# Inspect Front Door Fixed Glass Seals

**Classification** Campaign Bulletin    **Section/Group** 11 - Closures    **Country/Region** United States

**Year** 2016    **Model** Model X    **Version** All

Figure 1

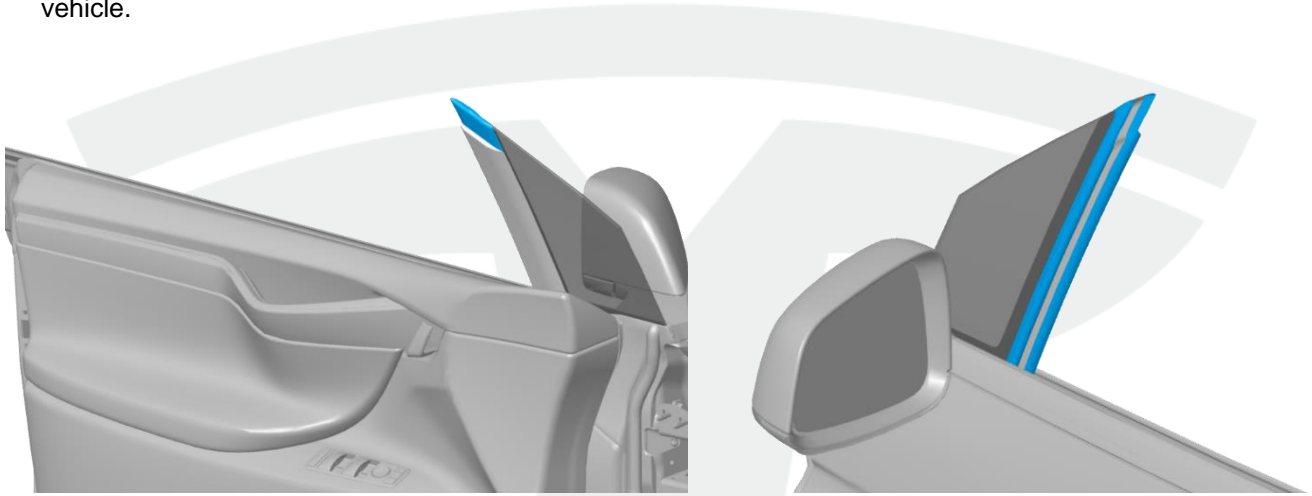
The seals on the front door fixed glass might have inadequate anti-wear coating, leading to premature wear. A worn seal might squeak when the door glass is moving or result in excessive wind noise.

1. Lower the LH front window.
2. Inspect the top of the inboard seal and both outboard seals on the front door fixed glass (Figures 1 and 2):
  - If the top of the inboard seal and the entire length of both outboard seals have a consistently gritty texture, the coating is adequate. Repeat the procedure on the RH side of the vehicle.
  - If any portion of the 3 seals has a smooth texture (Figure 3), the coating is inadequate. Replace the front door fixed glass (refer to Service Manual procedure 11501402), then repeat the procedure on the RH side of the vehicle.

Inspect the LH and RH front door fixed glass seals. If a seal has inadequate anti-wear coating, replace the front door fixed glass.
